# ELD Troubleshooting Chart Fixes for '96-98 Civic S/M

**HONDA ServiceNews**

Page 11-115, DTC P1297:

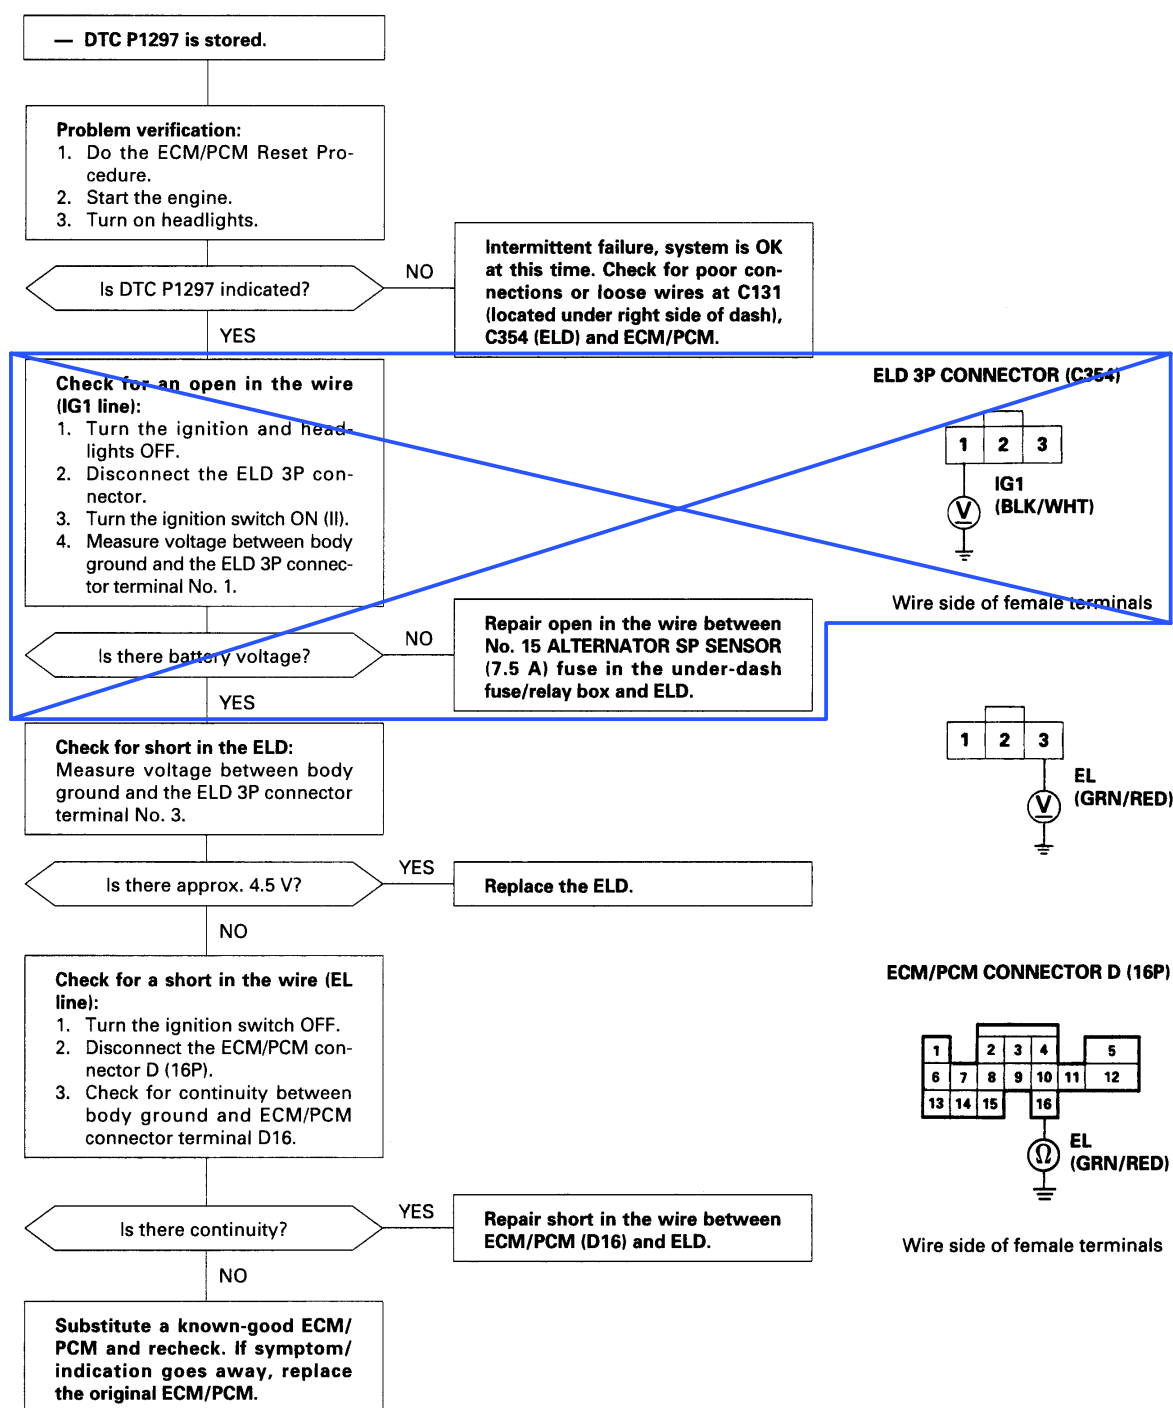
*Delete the info in the middle of the troubleshooting chart.*

**P1297** The scan tool indicates Diagnostic Trouble Code (DTC) P1297: A low voltage problem in the Electrical Load Detector (ELD) circuit.

## Page 11-116, DTC P1298:

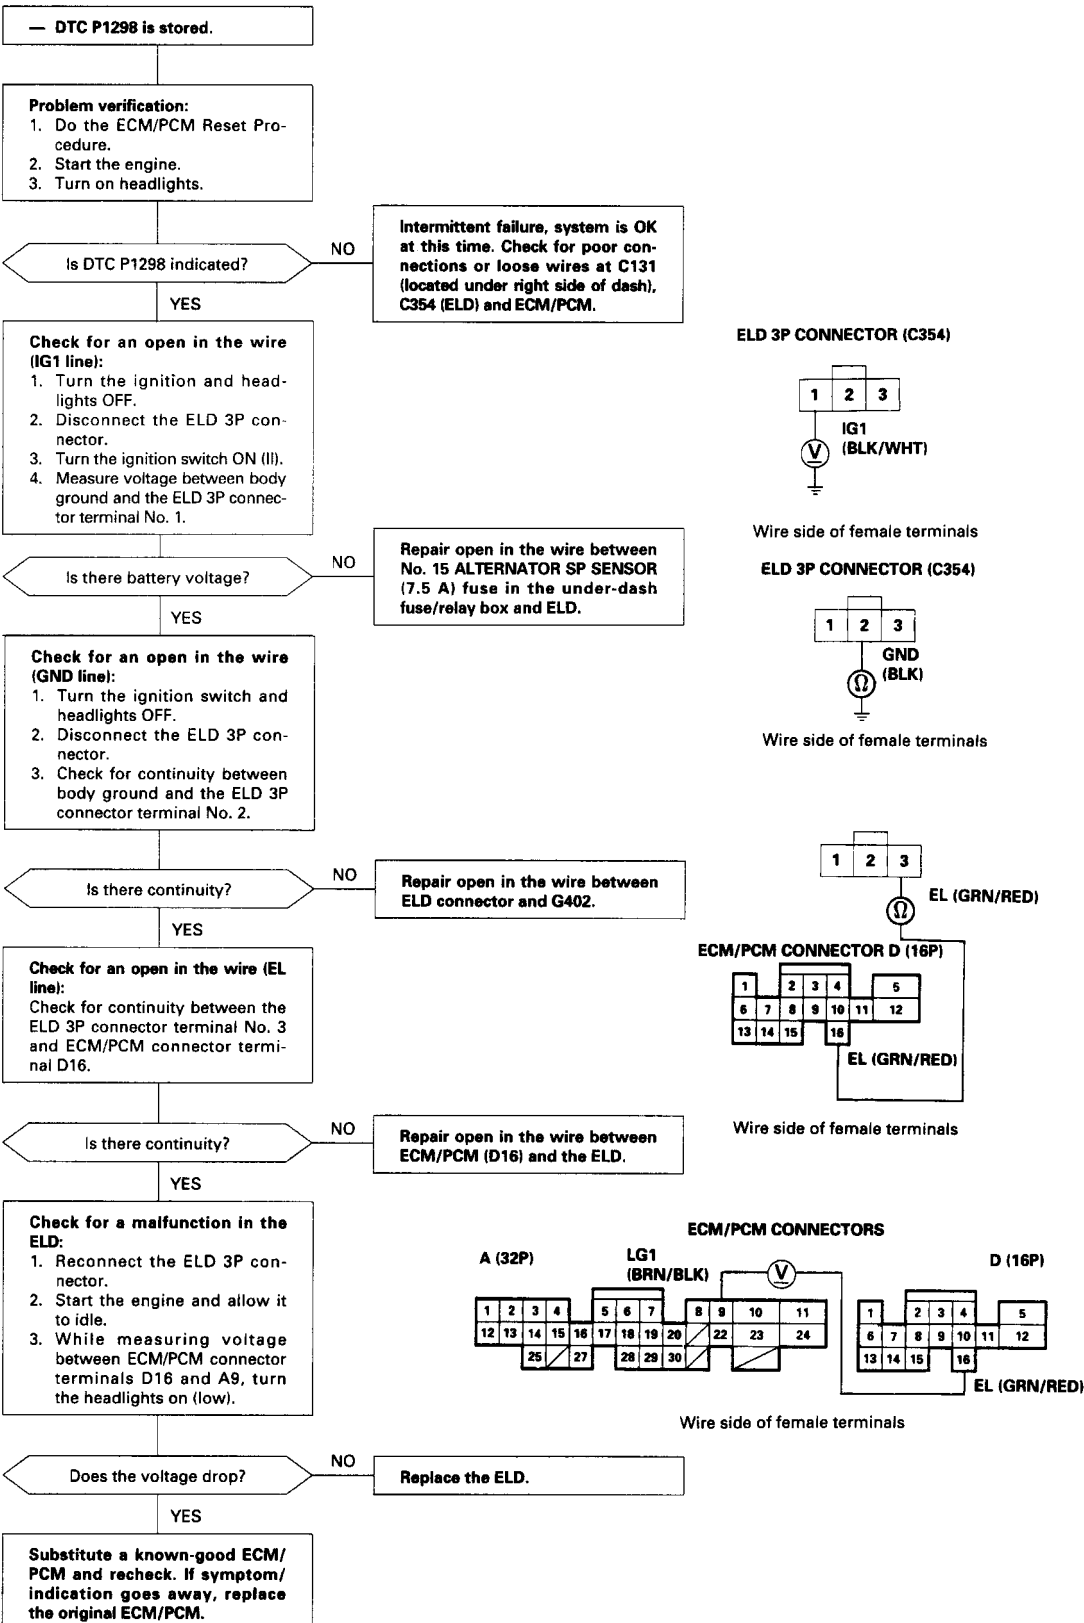
*Cross out the info on the entire page, and insert this correction page in front of it.*

**P1298** The scan tool indicates Diagnostic Trouble Code (DTC) P1298: A high voltage problem in the Electrical Load Detector (ELD) circuit.

## Fix the '98 Passport ETM Index

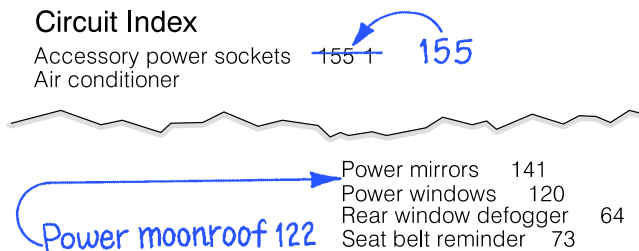
Here are two corrections for the '98 Passport ETM index. Make them on the indexes in front of the book, and on the back cover.

## VSS Troubleshooting Fix for '98 Odyssey S/M

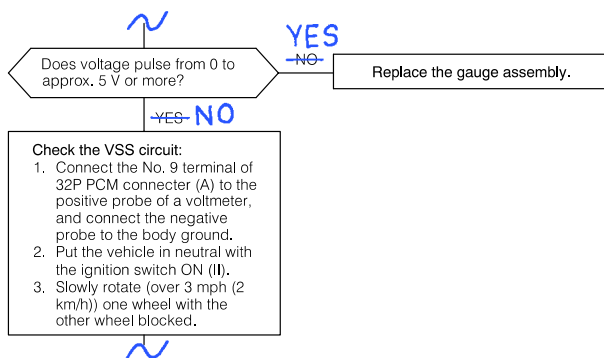
On page 23-118 of the '98 Odyssey S/M, one of the "Yes" "No" responses in the VSS troubleshooting chart is reversed. Correct your S/M like this:

## S/M Fix: Torquing Accord Head Bolts

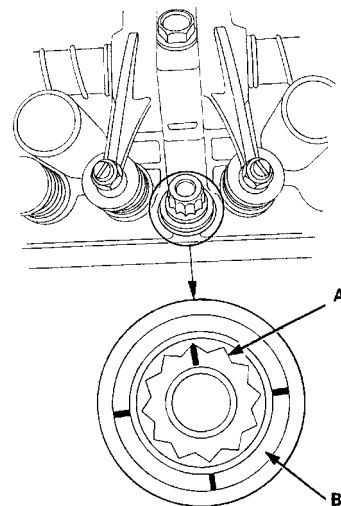
If you've ever torqued cylinder head bolts on a '98 Accord, you may have found the procedure on page 6-53 of the S/M to be a little confusing. Until we revise the procedure in the '98-99 Accord S/M, cross out steps 2, 3, and 4, and use these revised steps instead. (Or you could copy this page of S/N, cut out the steps, and tape them onto page 6-53.)

1. Make one mark on each bolt head (A) and three more at 90° intervals on the cylinder head boss (B) as shown.

2. Tighten each cylinder head bolt 90° (a quarter turn) in numbered sequence, then tighten them another 90° in sequence.
3. If you're using new bolts, tighten them an additional 90° in sequence.
